Rocker design

DWG NO. Rocker_design

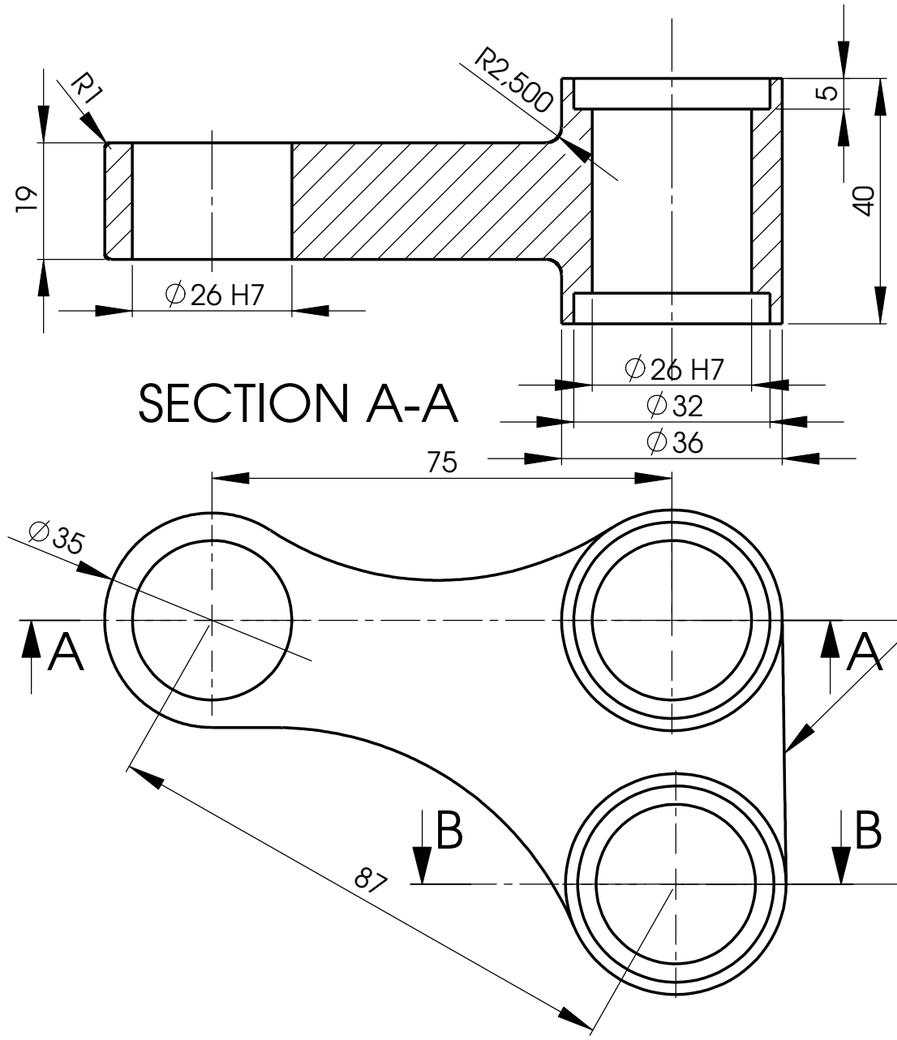
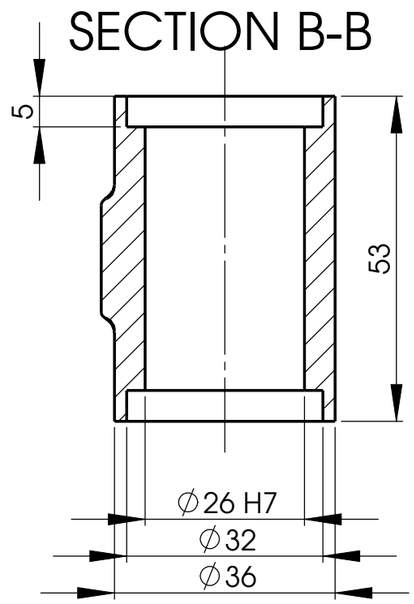
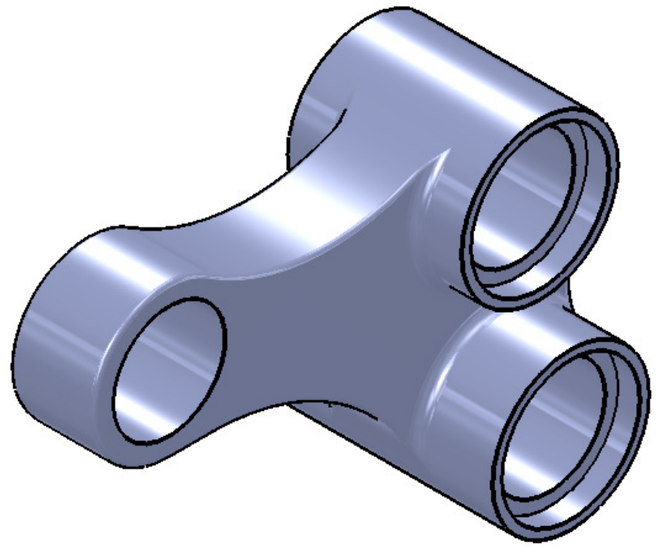
Please check that all measurements are correct.

H7 means a clearance between 0 and +0.021 mm
when the hole is Ø26. This clearance is recommended for bearings.

On this edge there is a 2.5 mm radius
